SYDNEY SOUTH WEST PLANNING PANEL

COUNCIL ASSESSMENT REPORT

Panel Reference	2017SSW031		
DA Number	DA-594/2013/B		
LGA	Liverpool City Council		
Proposed Development	 Modification Application lodged pursuant to Section 96(2) of the Environmental Planning and Assessment Act 1979. The application seeks to modify development consent no. DA-594/2013 which granted approval for - <i>Industrial Development in Two Stages Stage 1: Concept Masterplan for the industrial estate Stage 2: Construction industrial warehouse building, car parking, landscaping, driveway and road</i> The application seeks the following modifications to Stage 2 of the consent: Modification to the built form and layout of Warehouse 1 in Precinct A, including the construction of an additional basement car park for 44 parking spaces. Modification to car-parking and landscaping in front of Warehouse 1 		
Street Address	Lot 204 Beech Road, Casula LOT 204 DP 1090110		
Applicant	AMP Capital Funds Management Ltd

Figure 20: Extract of Carpark showing spaces to be removed marked with red.

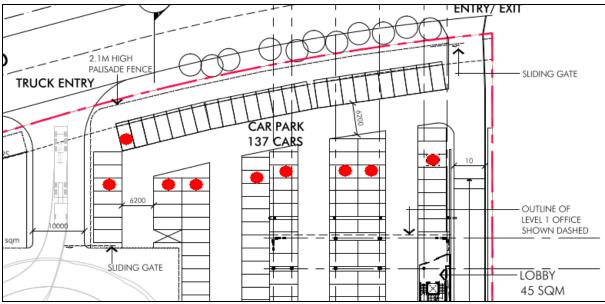
20. Car-parking And Access	DCP Requirements Warehouse rate = 1/250 Total Warehouse Area = 19,125 Required = 77 car spaces	Complies
	Work shop rate = 1/75 Total Workshop Area = 1000sqm Required = 14	
	Office rate = 1/35 Total Office Area = 2785 Required = 80	
	Total Required = 171	
	Proposed is 180	
	The car-parking on-site complies with the rate applied by LDCP 2008 for industrial buildings. 180 car-spaces are proposed which is a surplus 9 car-spaces. In light of the variation to the

PART 1 – GENERAL CONTRO	LS FOR ALL DEVELOPMENT	
	required 10m landscape buffer to Beech Road, it is considered appropriate to improve the landscape concept plan where possible to reduce the visual impact of the carpark on the street.	
	As such it is considered that 9 car spaces shall be removed (as indicated in red in the figure below this table) to accommodate a widening of the landscape buffer from 5m to 7.5m.	
	This additional 2.5m area is to landscaped in accordance with the approved Landscape Design Report. This will form part of conditions of consent.	
	The proposed 180 car spaces shall therefore be reduced to 171 by a condition of consent.	
	Approved number of car-spaces = 171
